UNITED STATES  
 NUCLEAR REGULATORY COMMISSION  
 WASHINGTON, D. C. 20555

VERMONT YANKEE NUCLEAR POWER STATION

Amendment No. 18  
License No. DPR-28

ATTACHMENT TO LICENSE AMENDMENT NO. 18  
CHANGE NO. 29 TO THE TECHNICAL SPECIFICATIONS  
FACILITY OPERATING LICENSE NO. DPR-28  
DOCKET NO. 50-271

FIGURE 2-102

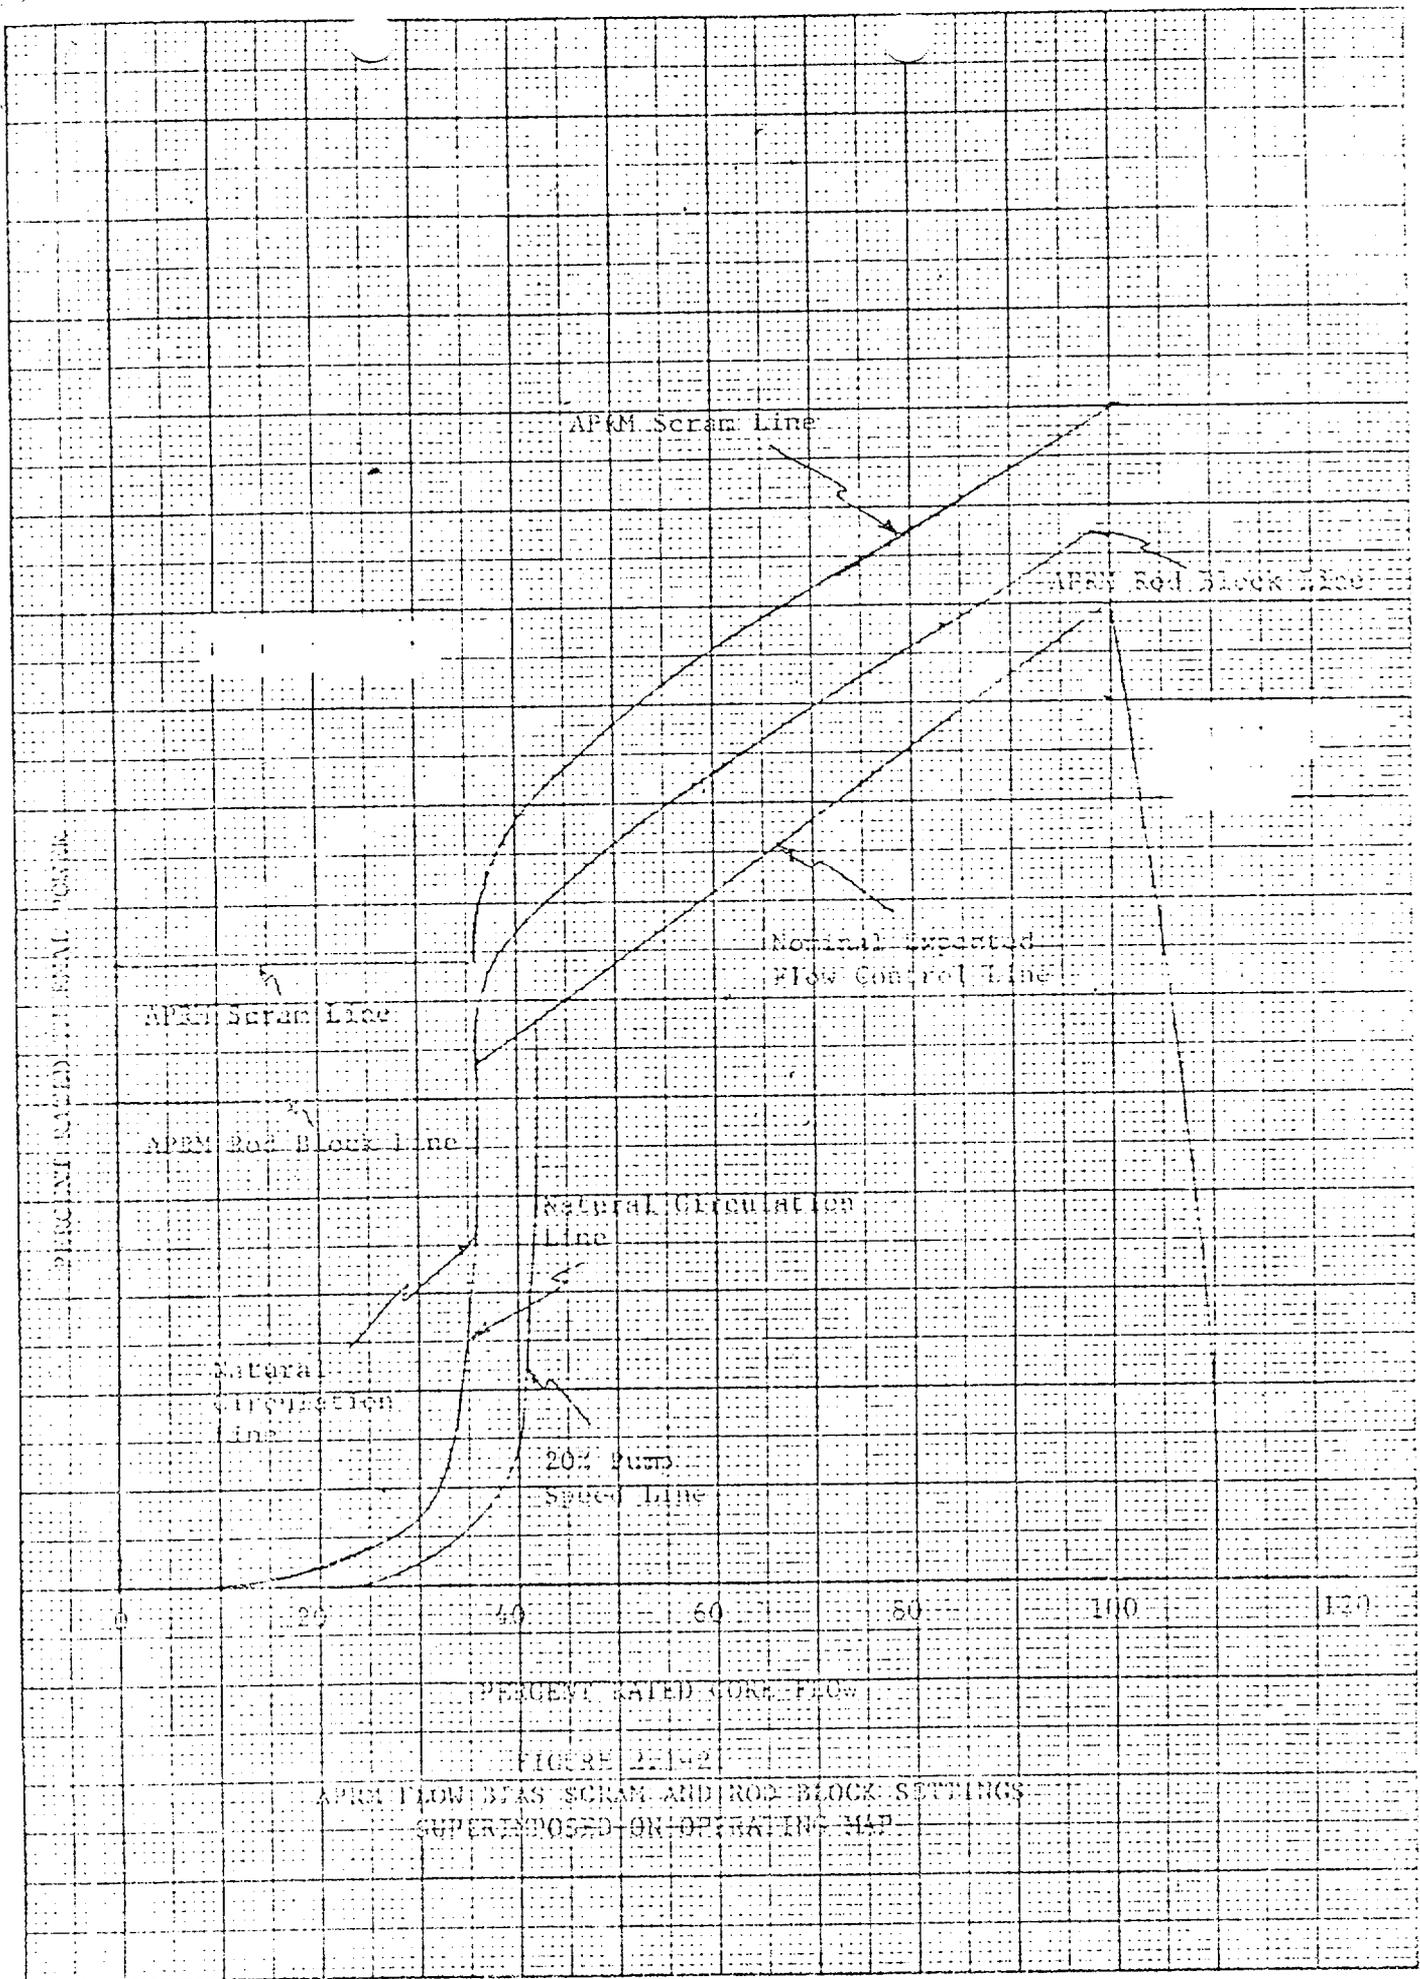
Figure 1.1.1 has been deleted and replaced with Figure 2.1.1. Adoption of GETAB/GEXL requires this Figure replacement.

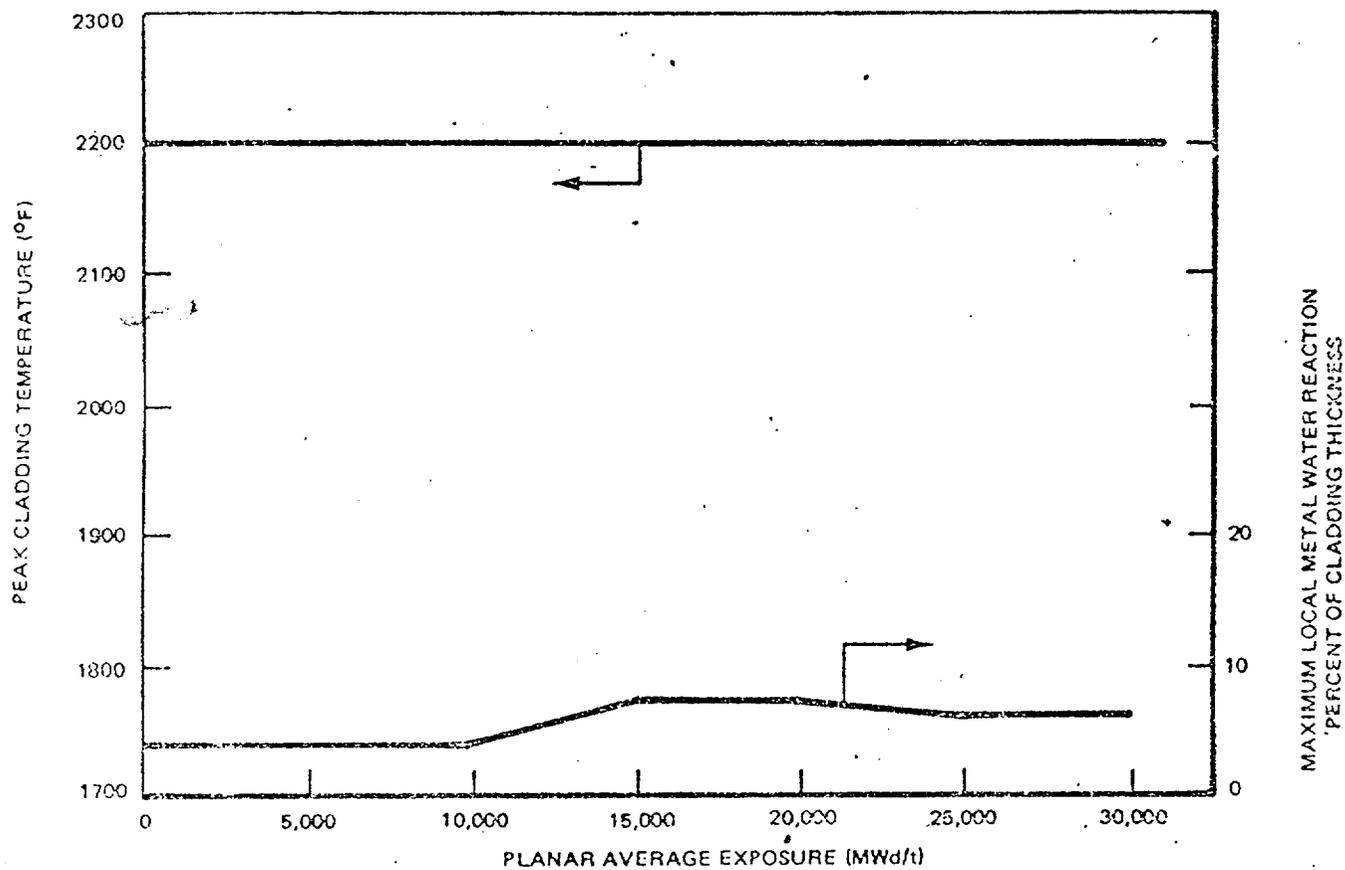
For core flows other than rated the Operating MCPR Limit shall be the above value multiplied by  $K_f$ , where  $K_f$  is given by Figure 3.11-2. If at any time during steady-state operation it is determined by normal surveillance that the limiting value for MCPR is being exceeded, action shall be initiated within 15 minutes to restore operation to within the prescribed limits. If the steady state MCPR is not returned to within the prescribed limits within two (2) hours, the reactor shall be brought to the cold shutdown condition within 36 hours. Surveillance and corresponding action shall continue until reactor operation is within the prescribed limits.

The  $K_f$  factor curves shown in Figure 3.11.2 were developed generically which are applicable to all BWR/2, BWR/3, and BWR/4 reactors. The  $K_f$  factors were derived using the flow control line corresponding to rated thermal power at rated core flow.
